REMARKS/ARGUMENTS

Serial No. 10/776,054
Reply to Office Action of April 18, 2005

Amendments to the Drawings:

Fig. 1
Prior Art

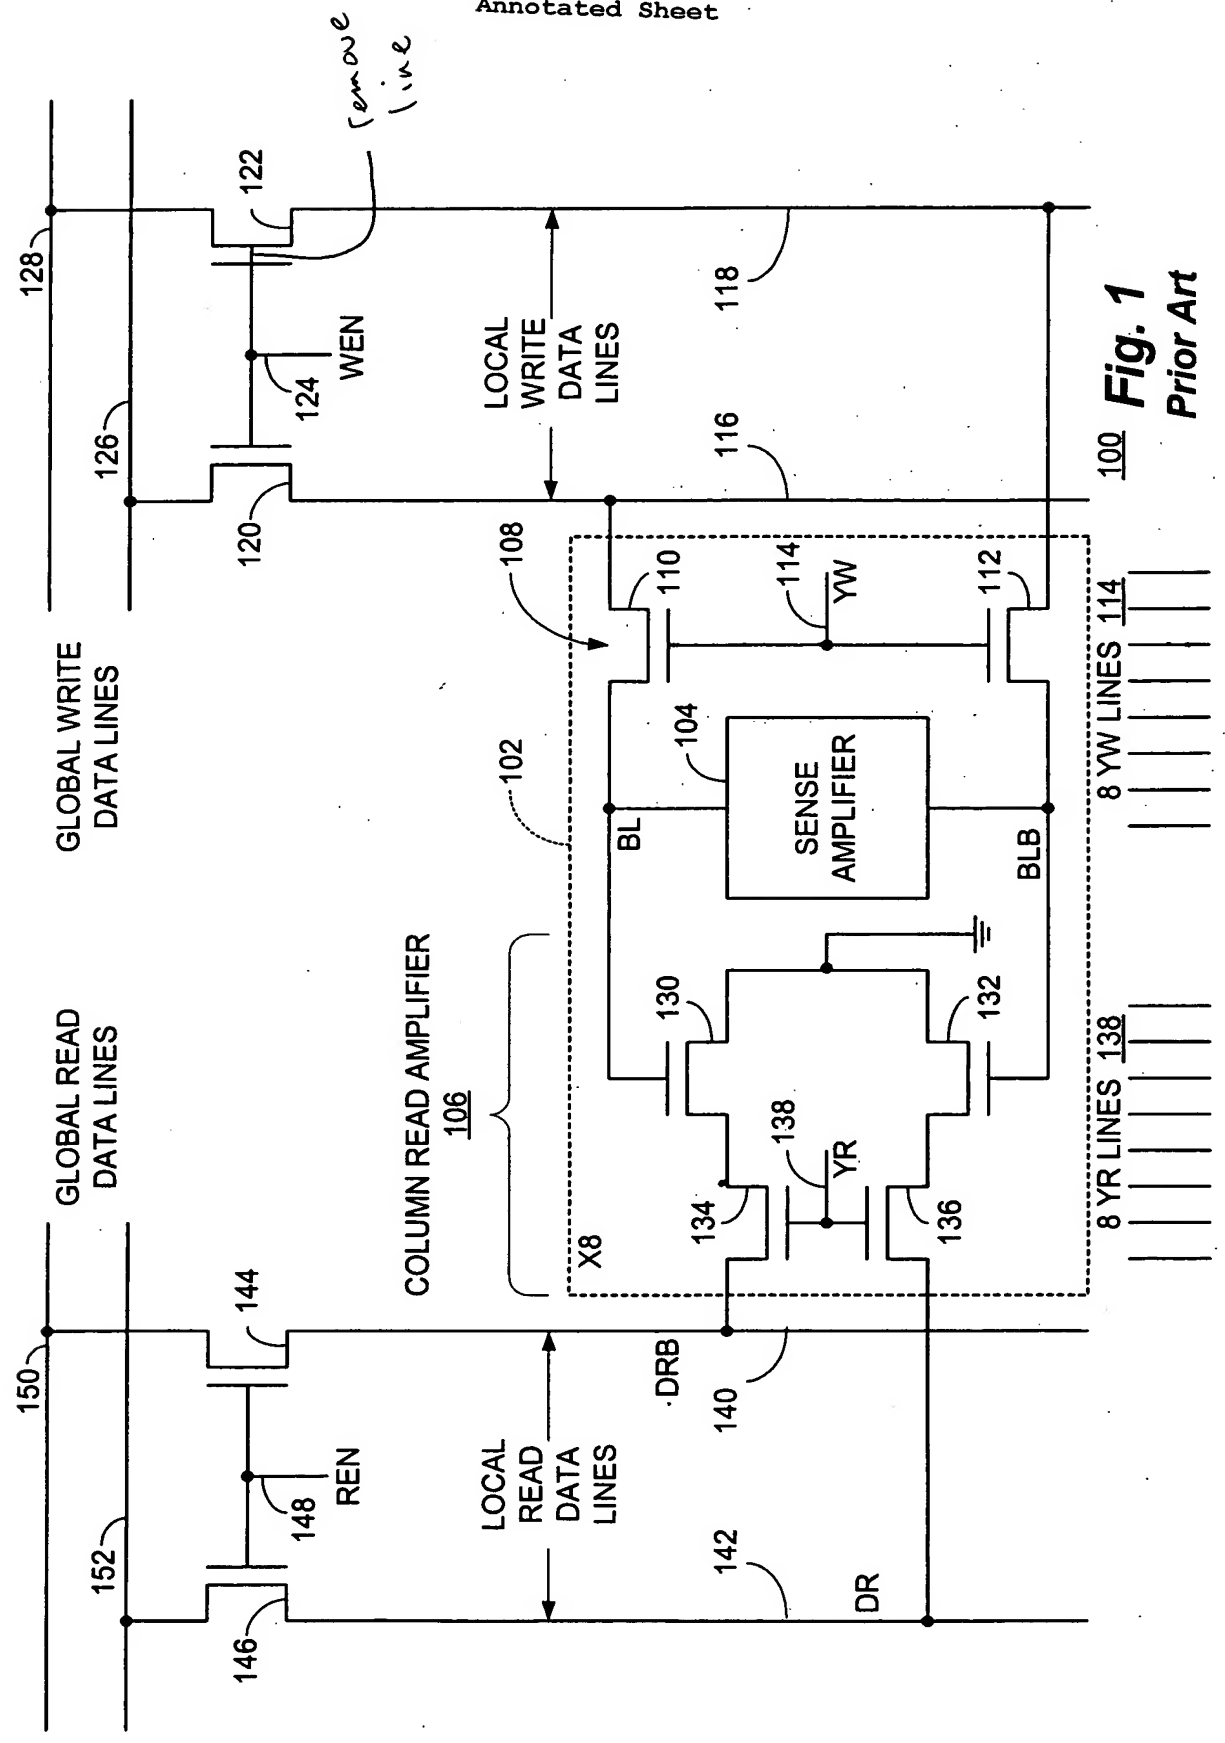
The objection to the "8YW LINES 114" reference character is respectfully traversed in part. This reference character should be read as "eight YW lines 114" and is partially mentioned in the specification at page 5, lines 14-17 and at page 5, lines 28-33. The specification has been amended to insert "at line 114". No new matter has been added to the specification, since support is found in FIG. 1.

A first sheet, which includes FIG. 1, replaces the original sheet including FIG. 1. Figure 1 has been amended to correct an informality regarding the symbol for transistor 122.
